**SUBJECT:** Savannah River Site's Responses to the Regulatory Comments on the Effectiveness Monitoring Report (EMR) for the C-Area Groundwater (CAGW) Operable Unit (OU) Removal Action (U) - July 2022 through June 2023 (SRNS-RP-2023-00913, Revision 0, October 2023) SEMS Number: 82

**SRS Responses to SCDHEC Comments on the Effectiveness Monitoring Report (EMR) for the C-Area Groundwater (CAGW) Operable Unit (OU) Removal Action (U) – July 2022 through June 2023, SEMS Number: 82, SRNS-RP-2023-00913, Revision 0, October 2023**

**SRS Responses to EPA Comments on the Effectiveness Monitoring Report (EMR) for the  
C-Area Groundwater (CAGW) Operable Unit (OU) Removal Action (U) –  
July 2022 through June 2023, SEMS Number: 82,  
SRNS-RP-2023-00913, Revision 0, October 2023**

**Figure 2b (Figure 11b in Rev 0 EMR). Castor Creek Tributary Surface Water TCE Trends**

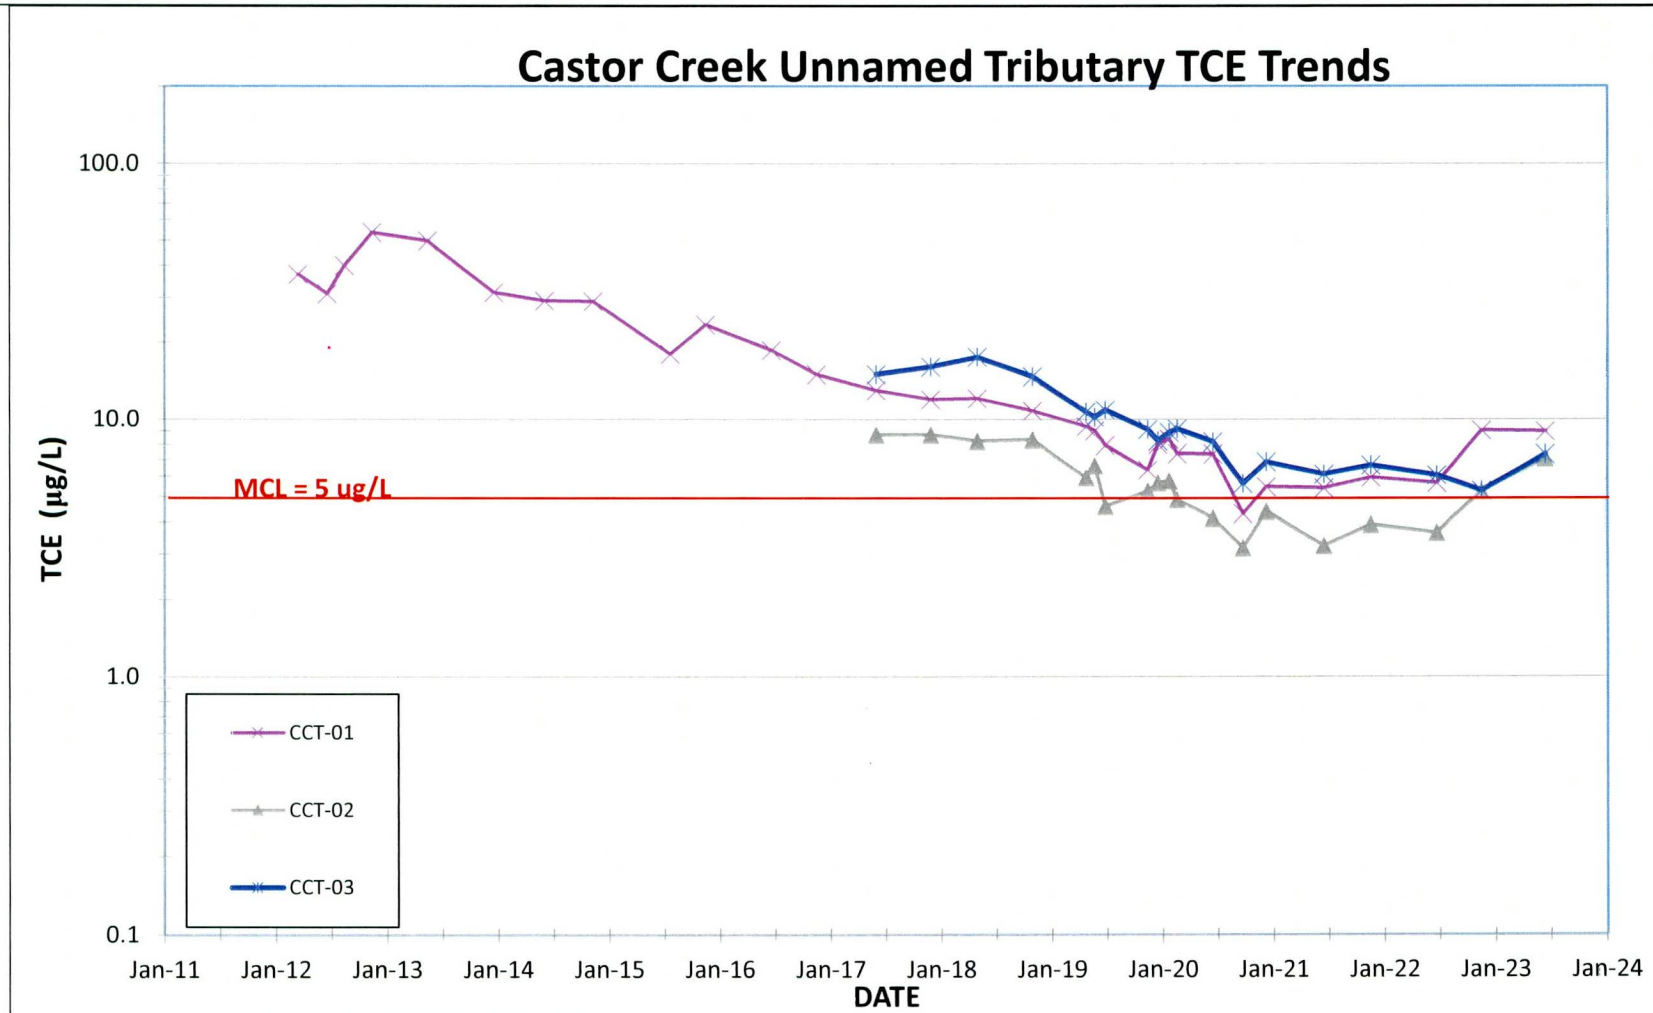
2. Some of the figure names and numbers are misaligned. There are two Figure 30s and two Figure 31s. Starting with Figure 10b, the figure names are misaligned until Figure 31. For example, Figure 10c, described in Section 3.4 of the text and in the List of Figures, references Former ERH-SVE TCE source area trends. In the figure section of the report, the figure number for the Former ERH-SVE TCE source area trends is Figure 12c.

3. Section 3.4, Groundwater and Surface Water Compliance, page 12. The second paragraph of the page reads “In 2Q23, CSB 15D and CSB020C groundwater TCE concentrations (37.6 µg/L and 40.2 µg/L, respectively) exceeded the TCE MCL (5 µg/L) (Figure 10b).” There is no Figure 10b attached to the report. Regardless of its presence, the title of Figure 10b, in the List of Figures, implies surface water trends. It is unlikely that groundwater results from CSB 15D and CSB020C would be included in this figure.

**There was a conversion error in the numbering of figures between the Word and PDF files. The correct figure numbers for Figure 11b and Figure 12c are Figure 10b and Figure 10c, respectively. Beginning with Figure 13 through Figure 30, the numbering**

is off by two. For example, Figure 13 should be Figure 11 and Figure 30 should be Figure 28. The text and figures in the next EMR will be verified to reference the correct numbering. Please see the attached corrected Figures 10a – 10c and Figure 11 (Figure 10a, Figure 11b, Figure 12c and Figure 13 in the Rev. 0 EMR). In the next EMR, Figure 11, or equivalent, will be referenced for wells CSB 15D and CSB020D, while surface water stations will reference Figure 10b, or equivalent. No changes to the current report are proposed.

**Figure 11 (Figure 13 in Rev. 0 EMR). CAGW RA Peripheral Stations TCE Trends**

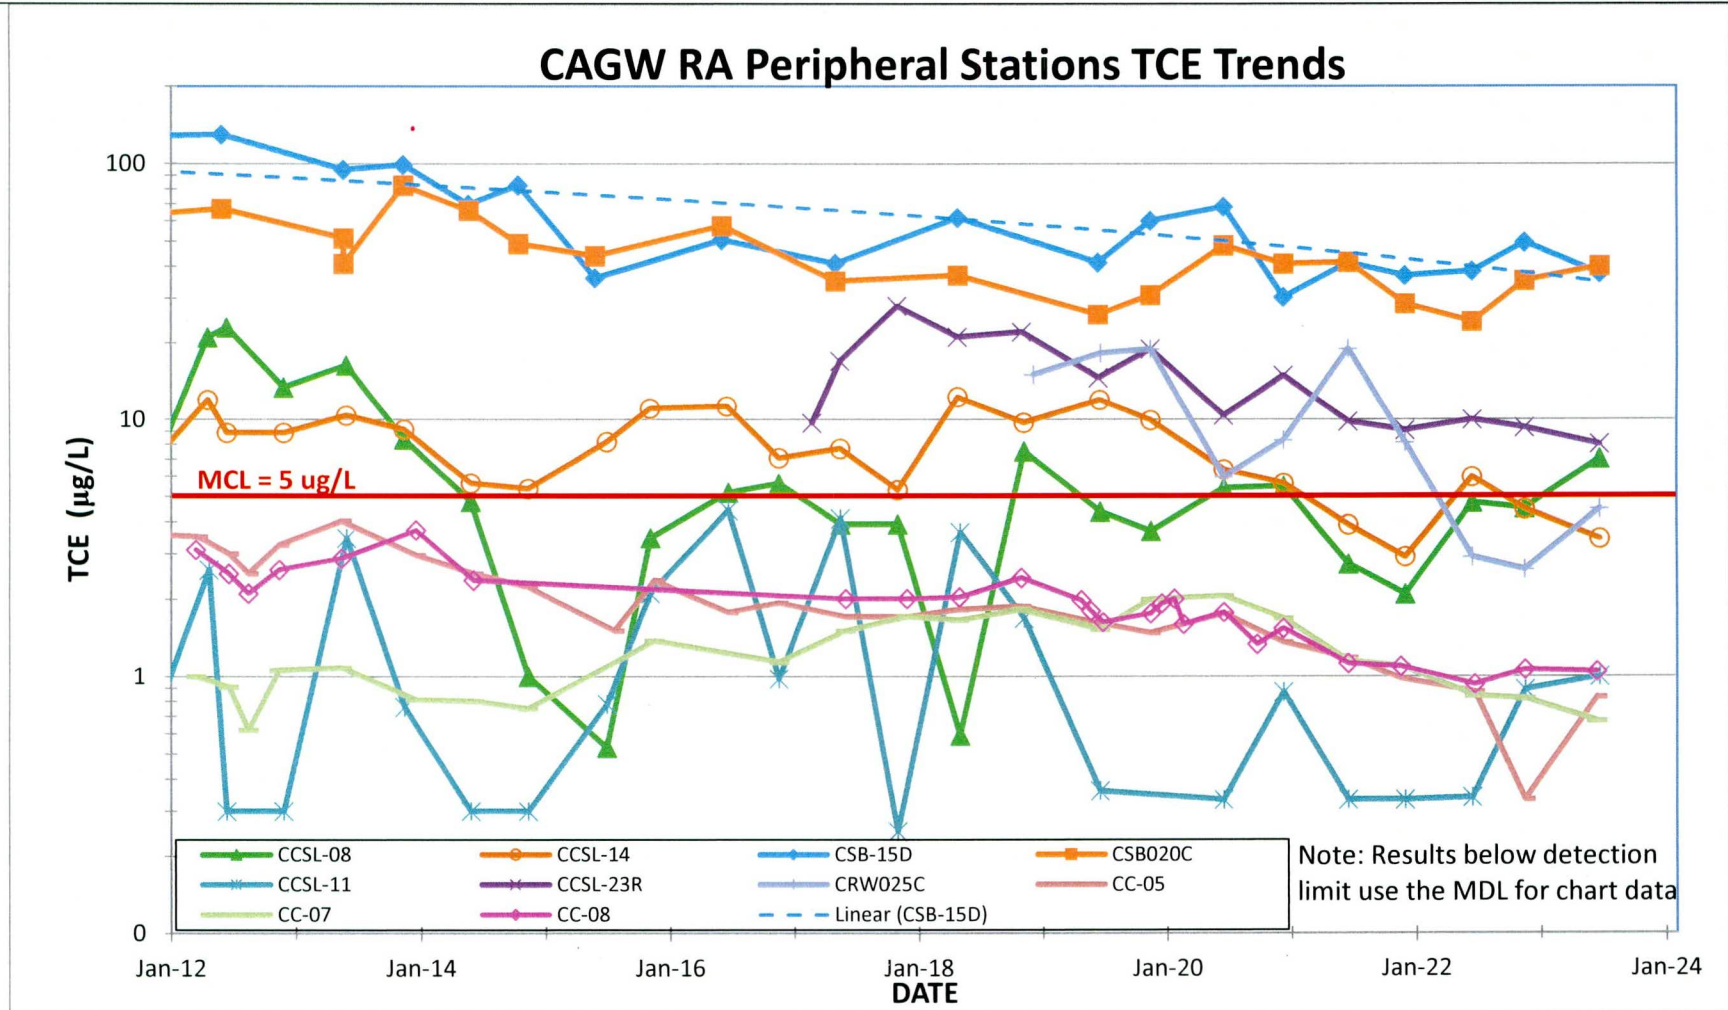
2. The numbering of the figures referenced in the text is inconsistent with the figures provided in the EMR. For example, in Section 3.4.1 (CAGW OU NTC RA), the discussion of the results for background wells CSB 15D and CSB020C references Figure 11, but the data for these background wells are provided in Figure 13 (CAGW RA Peripheral Stations TCE Trends). As another example, Section 3.4.1.6 (Methane) references Figures 15 and 16 for the methane results, but methane results are shown in Figures 17 and 18. *Please revise the EMR to resolve the discrepancies in the figure numbers referenced in the text and provided in the EMR.*

There was a conversion error in the numbering of figures between the Word and PDF files. The correct figure numbers for Figure 11b and Figure 12c are Figure 10b and Figure 10c, respectively. Beginning with Figure 13 through Figure 30, the numbering is off by two. For example, Figure 13 should be Figure 11 and Figure 30 should be Figure 28. The text and figures in the next EMR will be verified to reference the correct numbering.

Section 3.4.1 (CAGW OU NTC RA) in the discussion of the results for background wells CSB 15D and CSB020C, currently references Figure 11 but only for TCE results. Figure 13 contains the co-metabolic enzyme data for well CRW026C. Figures 15 and 16 depict methane results, but only for wells CRW023C and CRW026C, respectively. Please see the attached corrected Figures 15 and 16 (i.e., Figures 17 and 18 in the Rev. 0 EMR). No change to the current report is proposed.

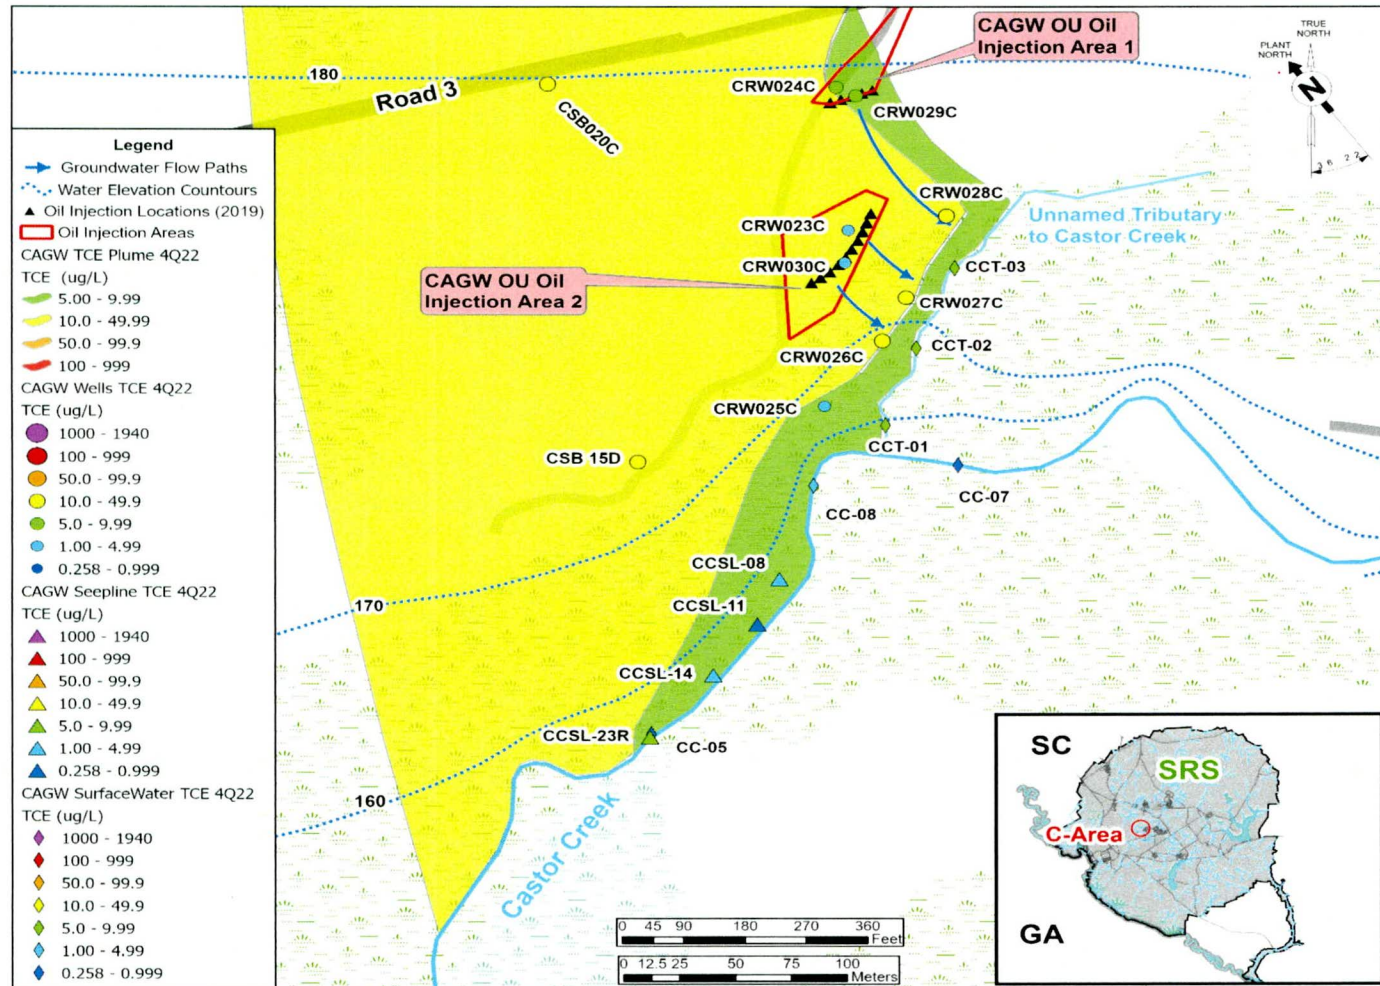
9. Figure E-1, November 2022 Potentiometric Contours for the Upper Aquifer Zone (UAZ), page E-3. Figure E-1 depicts November 2022 Potentiometric Contours for the Upper Aquifer Zone. The figure includes groundwater elevation contours but not the associated elevations that the contours represent. Please add numbers next to the contour lines indicating the groundwater elevations represented.

**The contour numbers will be added next to the contours in all the potentiometric figures in Appendix E in the next EMR, as represented by revised Figure E-1 (attached).**

**Revised Figure 4. CAGW OU NTC RA Areas (4Q2022)**

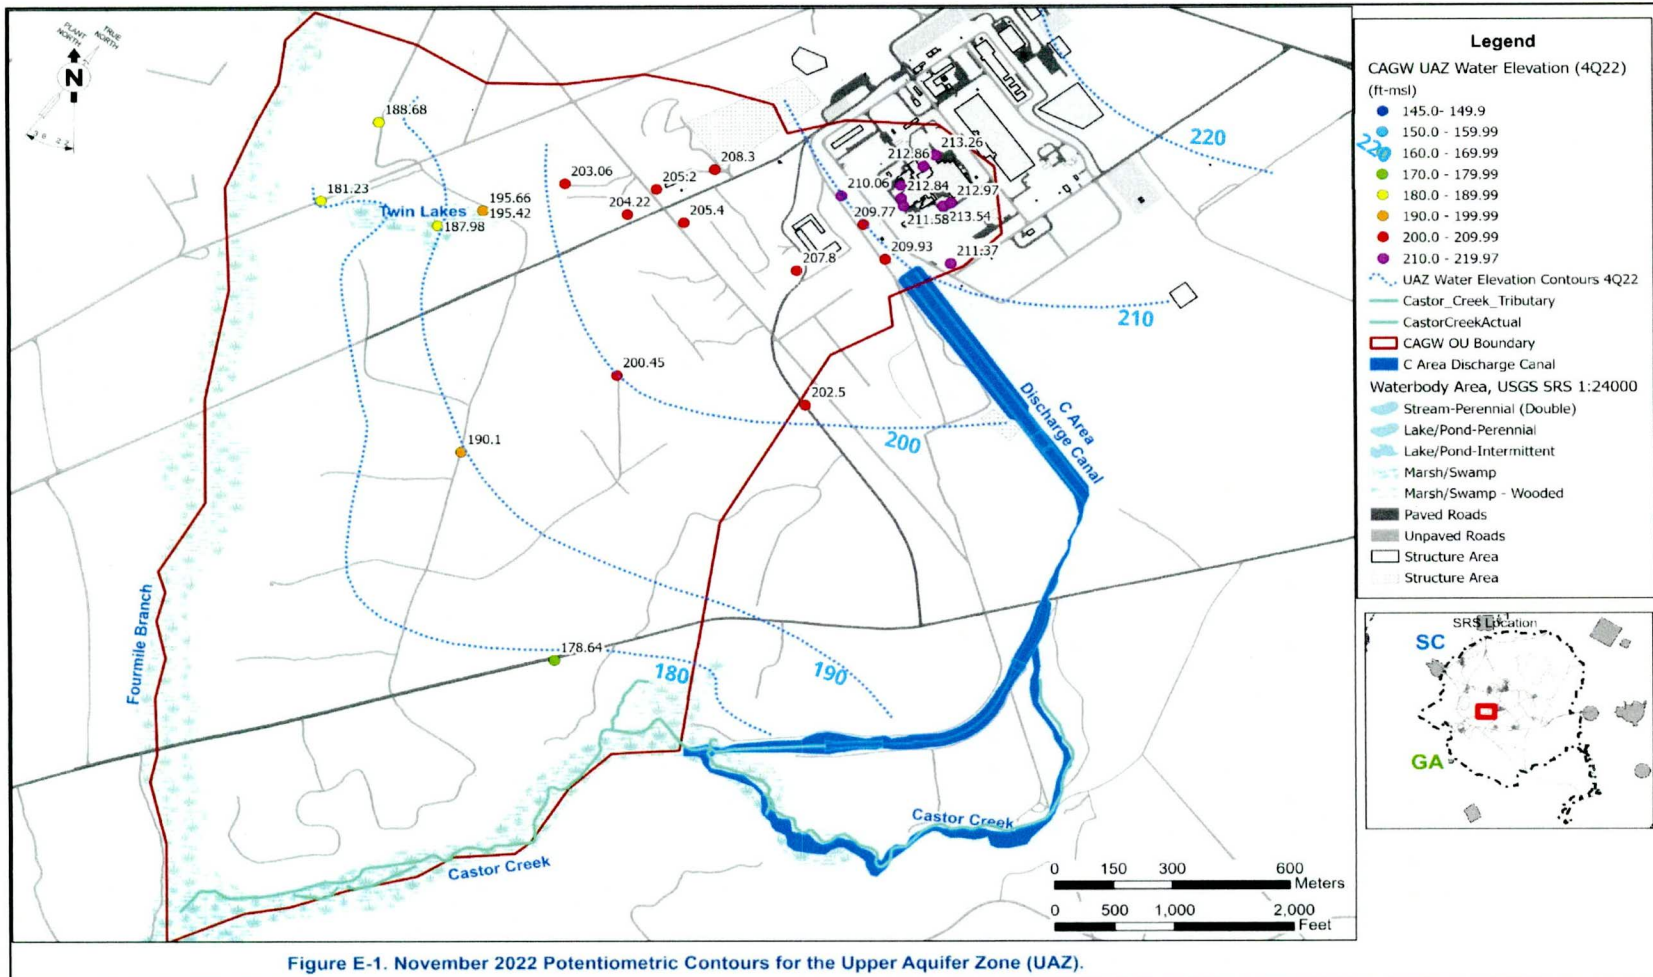
8. Figure 4, CAGW OU NTC RA Area (4Q2022), page 37. Figure 4 depicts CAGW OU NTC RA monitoring station results from 4Q22. CSB020B, CSB020D, CRW 13A, CSB-15B, and CSL001 are not part of the NTC monitoring network, were not sampled in 4Q22, and should not be included in this figure. Furthermore, CSB020B and CSB020D were not sampled during the sampling period detailed in this report although they are identified in Table 4 as CAGW OU monitoring wells that are scheduled to be sampled annually. Please consider revising Figure 4 to only include CAGW OU NTC RA results and discuss why CSB020B and CSB020D were not sampled during this reporting period.

**Figure 4 will be revised in the next EMR to only show stations sampled to support the CAGW NTC RA (Revised Figure 4 attached). Table 4 includes wells that are sampled to support the CAGW NTC RA and wells sampled for the CAGW OU network. In the next CAGW EMR, stations that support the NTC RA stations that support the overall CAGW OU will be depicted in separate tables. Wells CSB020B and CSB020D were sampled in 4Q22 as part of the broader CAGW OU monitoring network (see attached table). No change to the current report is proposed.**
